# **Noise Feasibility Study Proposed Commercial Development** 16054, 16060 & 16068 Airport Road Caledon, Ontario

Town File No: POPA 19-07, RZ 19-10, SPA 19-66

Peer Review Comments and HGC Engineering Responses

### Valcoustics Peer Review Comments – dated June 3, 2020

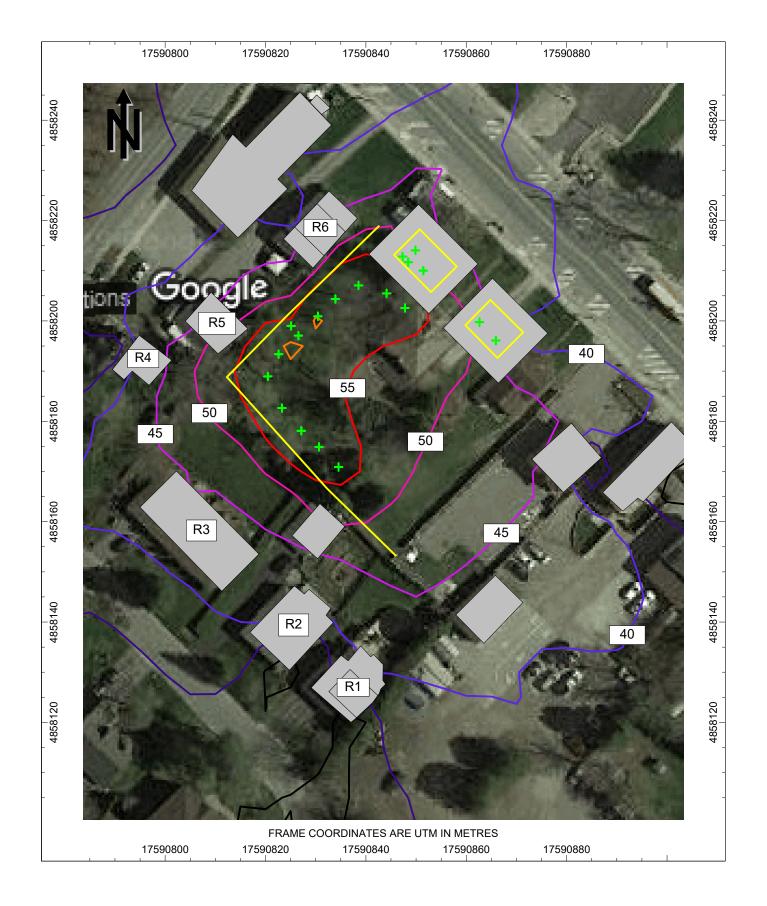
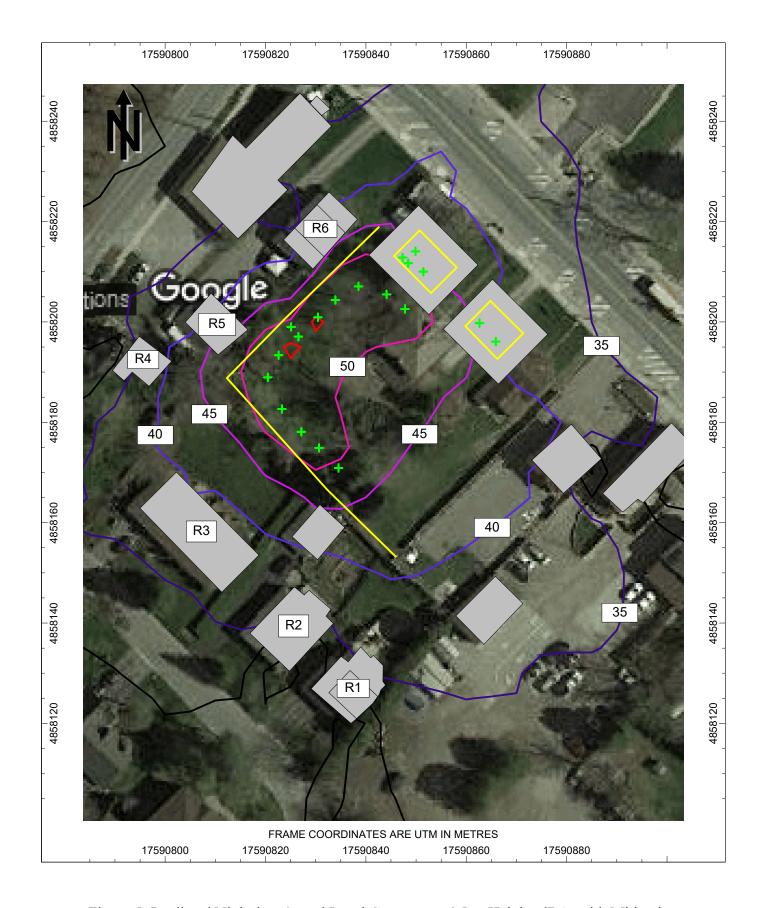
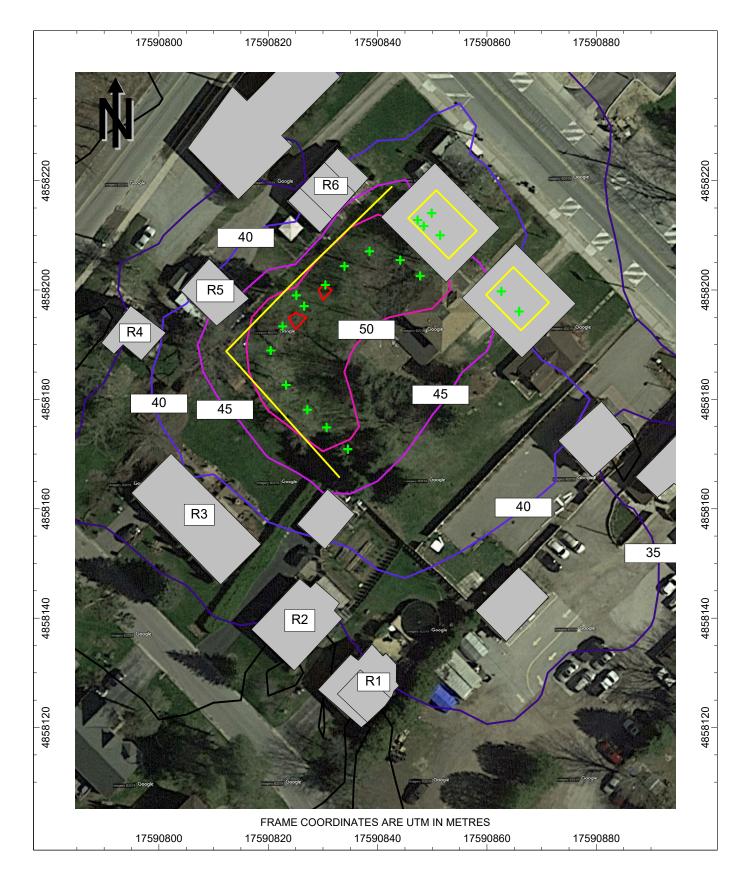
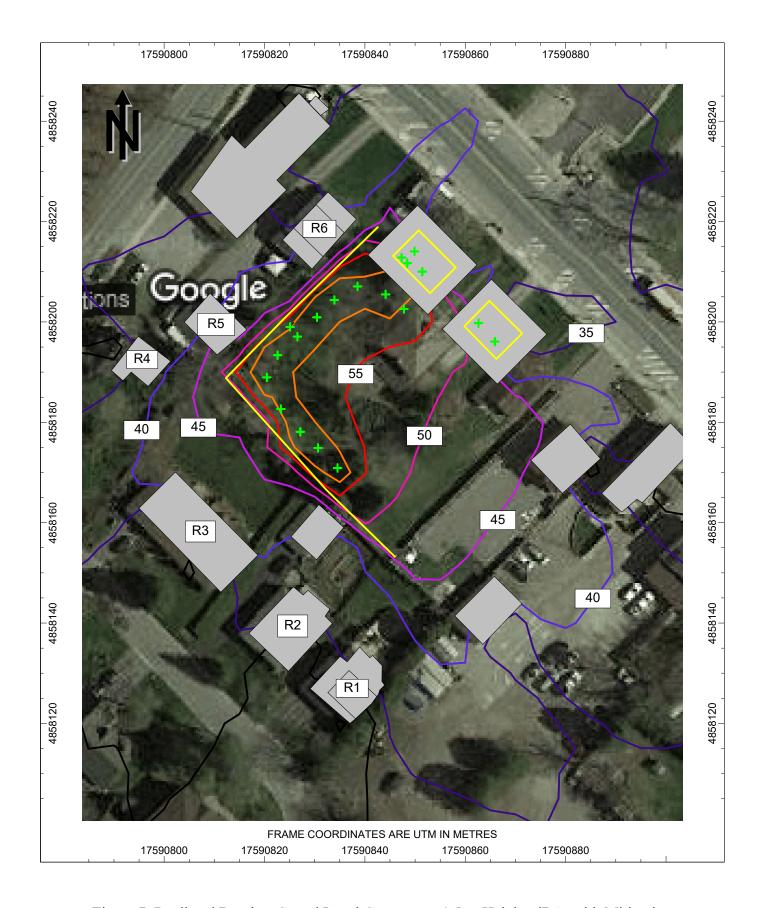
In addition, a table and/or figures showing the worst case mitigated sound levels at the points of reception should also be included as part of the report to confirm that the noise guideline and by-law requirements are being met.

Noted. These figures can be provided in the revised noise study.
